DEVELOPMENT REVIEW BOARD REPORT

Raintree Internalized Community Storage 35-DR-2019

Location: North Pima Road (217-15-035A)

Request: Request approval of the site plan, landscape plan, and building elevations for an internalized community storage building, with approximately 112,000 square feet of building area in a 2-story-tall building with a basement, all on a 2.5-acre site.

ELEVATION - WEST

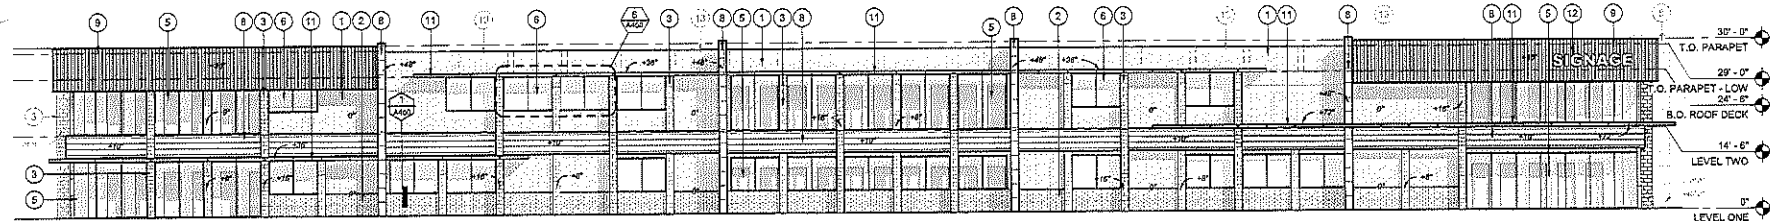
During the last Development Review Board meeting, staff and board members expressed concern with the amount of false-front storage display windows along the west elevation as it can act as a form of signage for the tenant as well a beacon of light when the full-length windows are illuminated during the evening. The Commercial Design Guidelines state that brand identity should not be the dominant architectural feature and lighting should be used to highlight special features as opposed to major portions of buildings.

To address the board's concerns and further align with the design guidelines, the applicant revised the west elevation by completely removing the center window display on the first floor and eliminating a full window pane from the remaining display areas to result in shorter segments (see attachment #8). In addition, the applicant provided a detail for the internal display lighting (see attachment #16) which staff recommends be recessed and have a lumen and timing limitation per stipulation #25 and #26.
